Access Compliance Report

Public Rights-of-Way

(Curb Ramps)

Intersection ID: 13538	Main Street: SOUTHWOOD_AV	Cross Street: W_PARK_AV	Location:	N
ADA ID: 7BDE6B168745	Ramp Type: BlendTrans1	Initial Pass/Fail: Fail	Overall Compliance: No	Severity Score: 1.25
Codes/Mitigation Info/Possible Solution		Field Measurements/Component Compliance

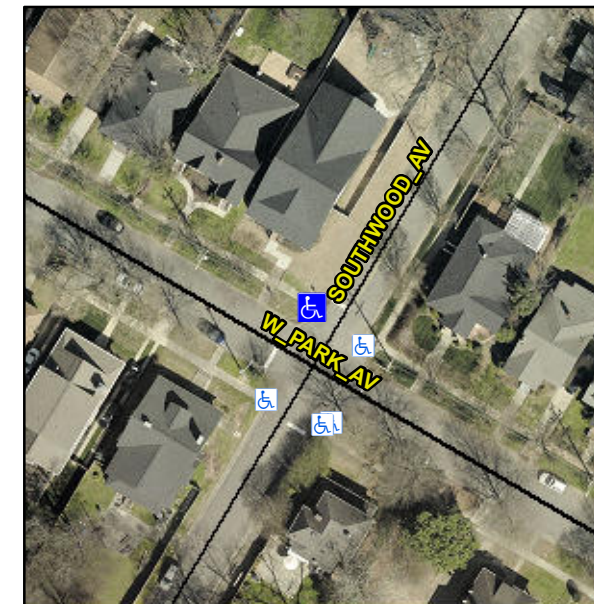
Not Found, R304.5.3

Compliance	Description	Data	Compliance	Description	Data
N/A	Ramp Length (in)	64.0	Yes	BlendTrans Slope (%)	3.5
Yes	Ramp Width (in)	60.0	No	BlendTrans XSlope (%)	4.4
N/A	Flare Type LT	N/A	N/A	Flare Type RT	N/A
N/A	Flare Slope LT (%)	N/A	N/A	Flare Slope RT (%)	N/A
N/A	Flare Traversable LT?	N/A	N/A	Flare Traversable RT?	N/A
N/A	Landing Length (in)	N/A	N/A	DWS Provided?	N/A
N/A	Landing Width (in)	N/A	N/A	DWS Contrast?	N/A
N/A	Landing Slope (%)	N/A	N/A	DWS Length (in)	N/A
N/A	Landing X Slope (%)	N/A	N/A	DWS Full Width?	N/A
N/A	Landing Curb? (Y/N)	N/A	N/A	DWS Offset (in)	N/A
N/A	Shared Landing?	N/A			
N/A	Gutter Ponding?	N/A	N/A	Gutter Slope (%)	N/A
N/A	Gutter Lip Ht (in)	N/A	N/A	Gutter X Slope (%)	N/A
N/A	Painted X Walk1?	No	N/A	Painted X Walk2?	No
	X Walk 1 Direction	To SW		X Walk 2 Direction	To SE
	X Walk 1 Width (in)	N/A		X Walk 2 Width (in)	N/A
	X Walk 1 Slope (%)	2.8		X Walk 2 Slope (%)	4.5
	X Walk 1 X Slope (%)	1.6		X Walk 2 X Slope (%)	5.9

N/A	Ramp inside XWalk1?	N/A	N/A	Ramp inside XWalk2?	N/A
	Road Slope (%)	4.0		Clear Space?	N/A
	Road X Slope (%)	3.6	N/A	Clear Space to XWalk (in)	N/A
N/A	Any Obstructions?	N/A	N/A	Storm Grate/Utility Hazard?	N/A
	Obstruction Type			Storm Grate/Utility Type	
		N/A			N/A
			Yes	Surface Condition? (G/P)	Good
			No	Curb Slope (%)	19.4

Remove & Replace Curb Ramp With Two New Directional Ramps or Equivalent.
